Addendum 2  
Kings Bluff Raw Water Transmission Main  
August 16, 2019

Below are changes and or clarifications to the bid documents for this project. This Addendum forms a part of the Contract Documents and modifies the original bidding documents as noted below. Acknowledge receipt of this Addendum as required in the bid documents. Failure to do so may subject Bidder to disqualification.

SHEET NO:  
**C-50**

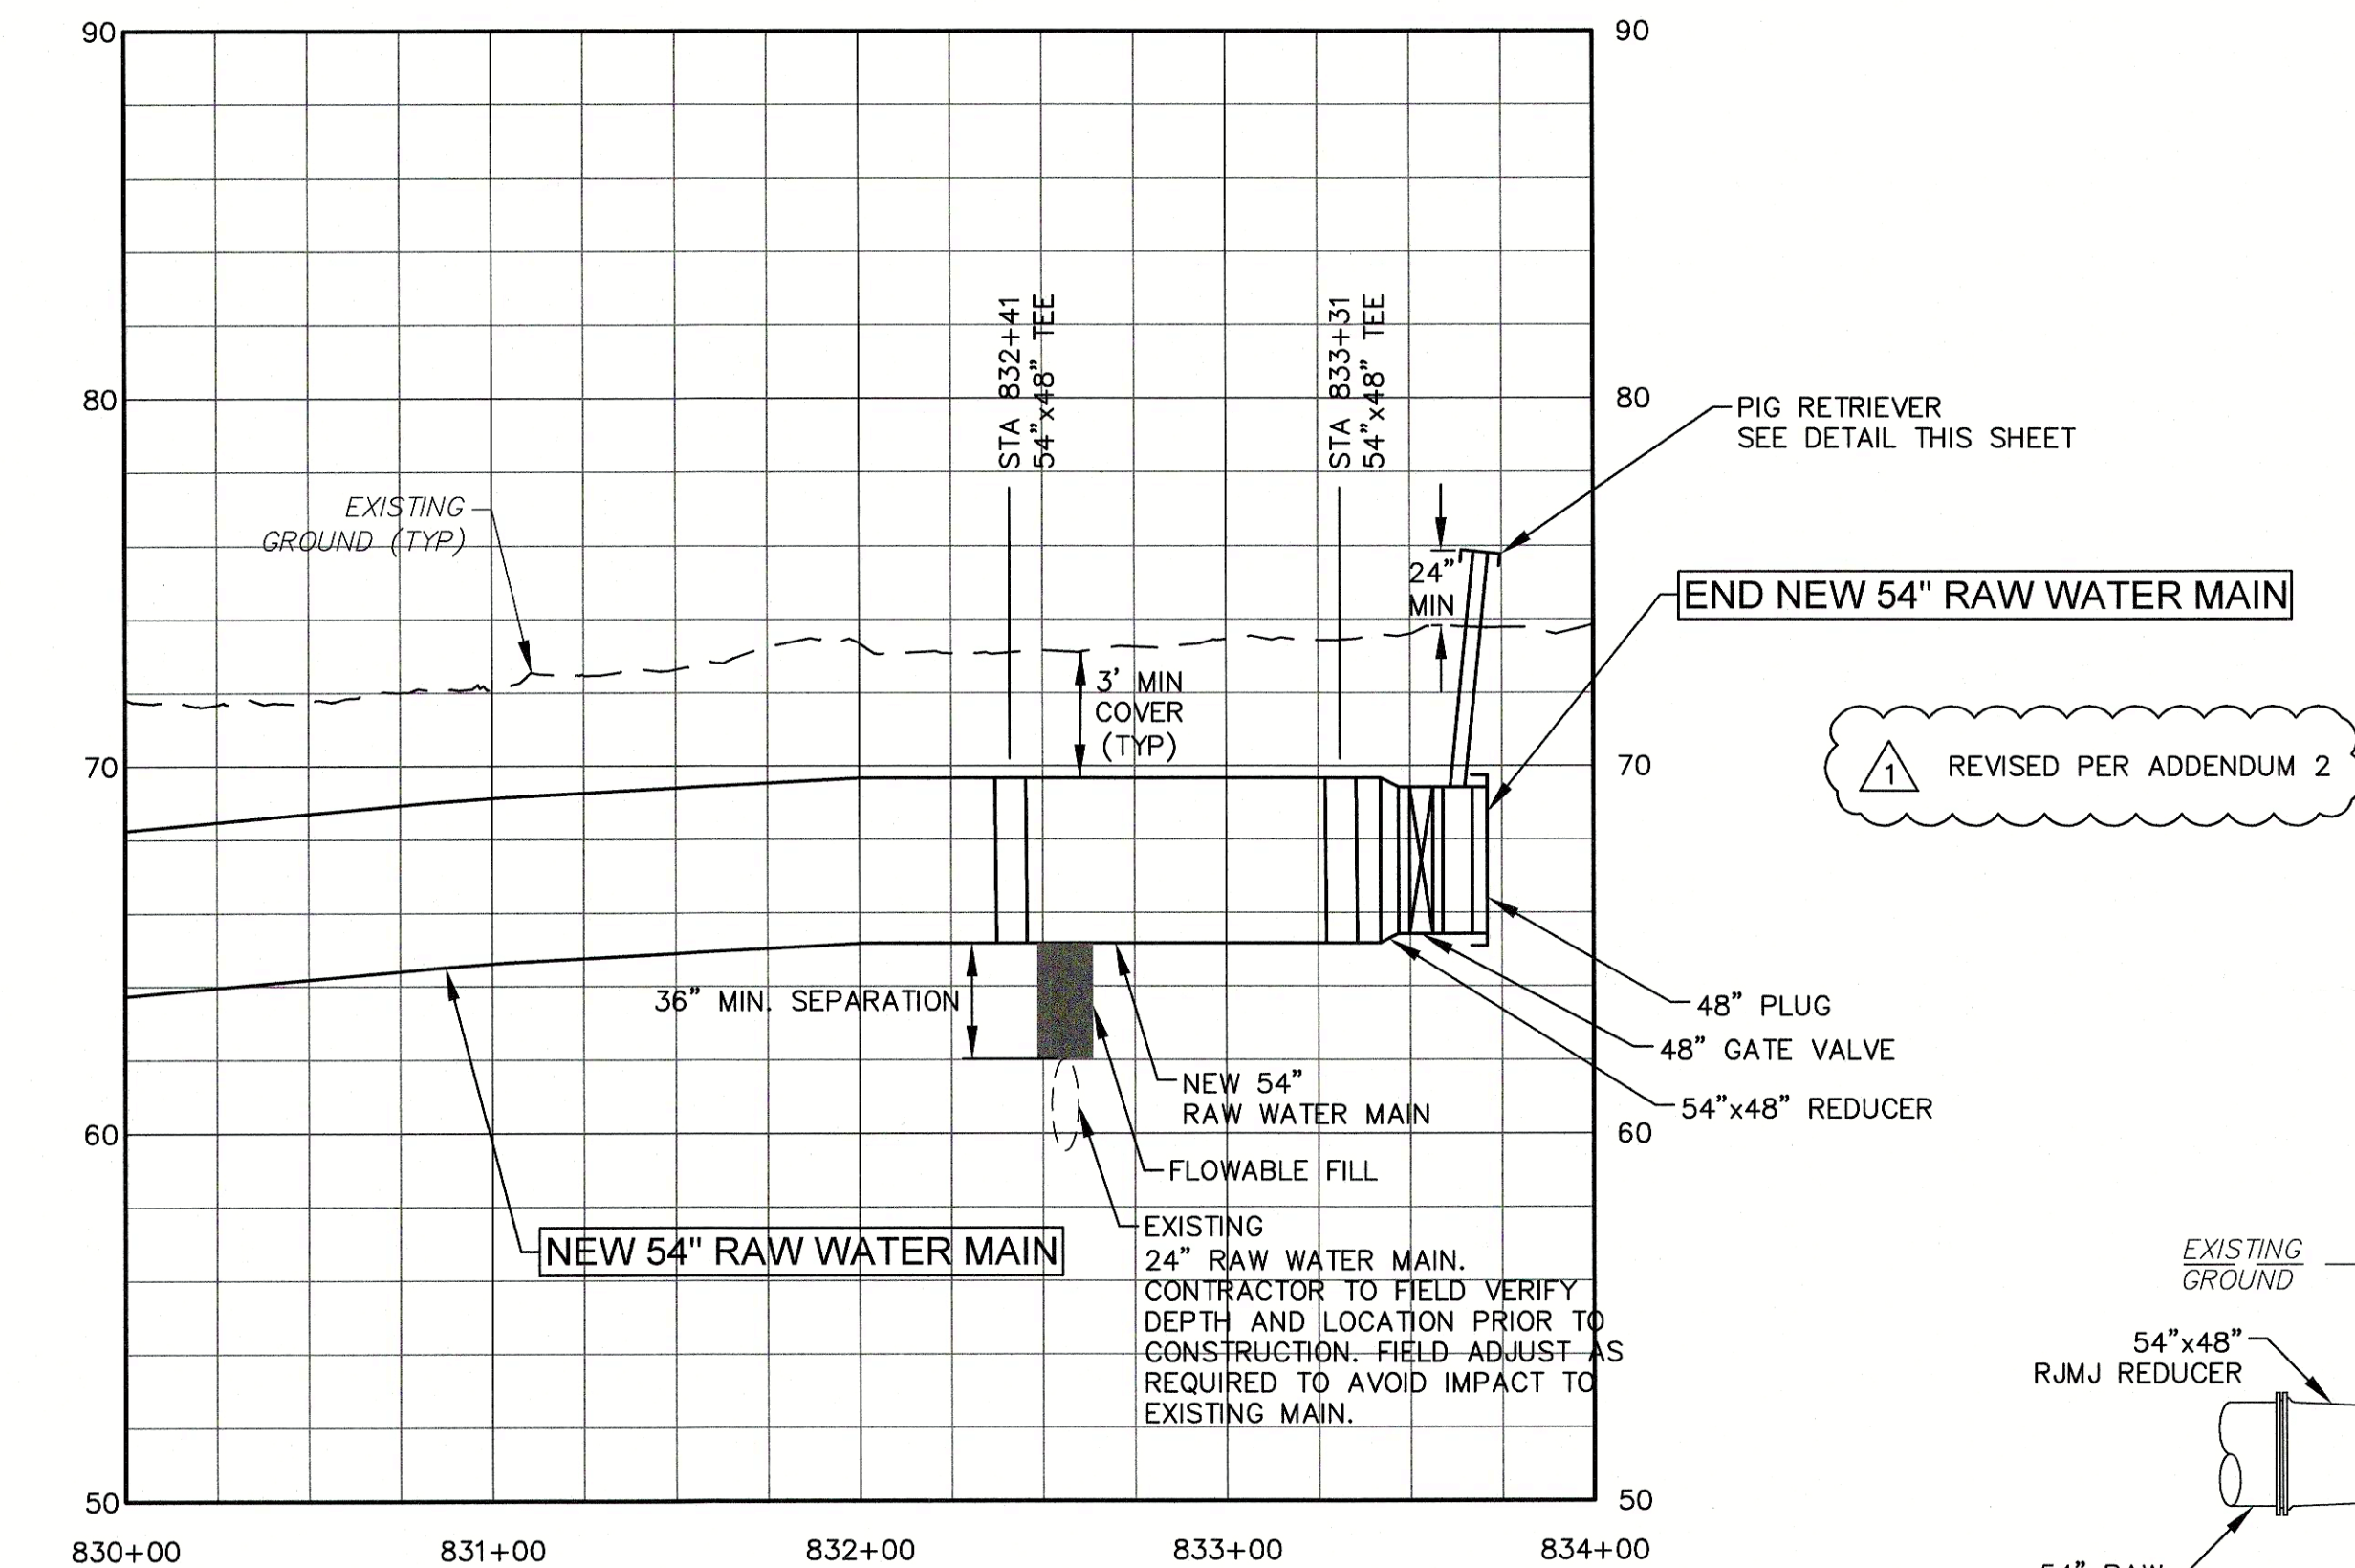
Q43. On plan sheet C-50 the plan, profile and inset are not congruent. The profile shows 2 pig retrievers and does not call out the tee for the interconnect. Please clarify.

Q51. Please refer to drawing sheet no C-50. Please advise if the new pig retriever, indicated on the 54" at approx. station 832+20, in the profile view, is required. This item is not indicated in the plan view.

Revised drawing C-50 is attached.

A43. See revised sheet C-50

A51. See revised sheet C-50

TYPICAL PIPE EMBEDMENT DETAIL  
NOT TO SCALE

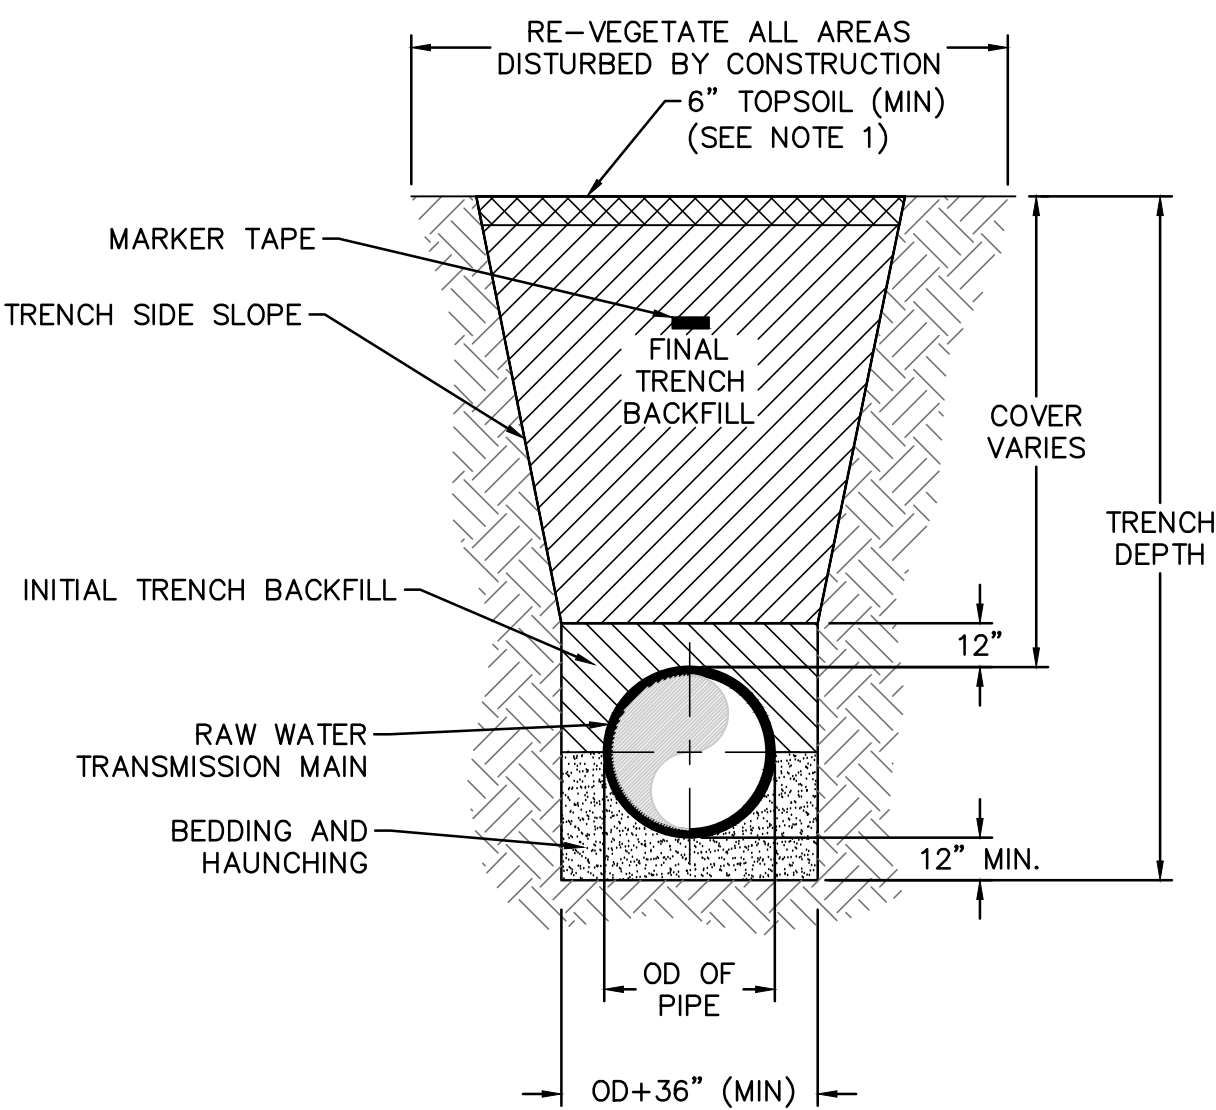
- Q1. Do both pipe materials get bedded below the pipe with 12 inches of NCDOT 57 or 67 Stone?  
A1. Yes, both pipe materials require a minimum 12 inches of washed stone below the pipe. See revised typical pipe embedment detail provided with this addendum.

- Q2. Does NCDOT 57 or 67 Stone get placed above the bedding to the spring line of the pipe in the “haunching” zone for steel pipe?  
A2. Yes, both pipe materials require stone to be placed to the spring line of the pipe for haunching. See revised typical pipe embedment detail provided with this addendum.

Q11. In addendum #1 Q10 There still is not a clear interpretation of the bedding, it now sounds like you are only requiring a min 12" of bedding stone under the pipe, you do not mention haunching of 50% of the pipe which the detail shows on the D-5 which you reference. Please clarify if your intention is the bed and Haunch to 50% of the pipe.

soft soils should be undercut as determined in the field. Please clarify if this detail requires aggregate stone (either #57 or #67 stone) to be installed or if the Select Material (Class III, IV, V, or VI) can be used in the Bedding/Haunching and Initial Backfill Zone.

Revised "Typical Pipe Embedment Detail" Sheet D-5 is attached.

A11. Bedding and haunching of the pipe will require the use of stone and shall be a minimum of 12" below the pipe up to the spring line of the pipe (50%). See revised detail provided with this addendum.

A30. Aggregate stone is required for bedding and haunching. Select material or insitu material meeting the specifications may be used for initial backfill zone. See revised typical pipe embedment detail provided with this addendum.
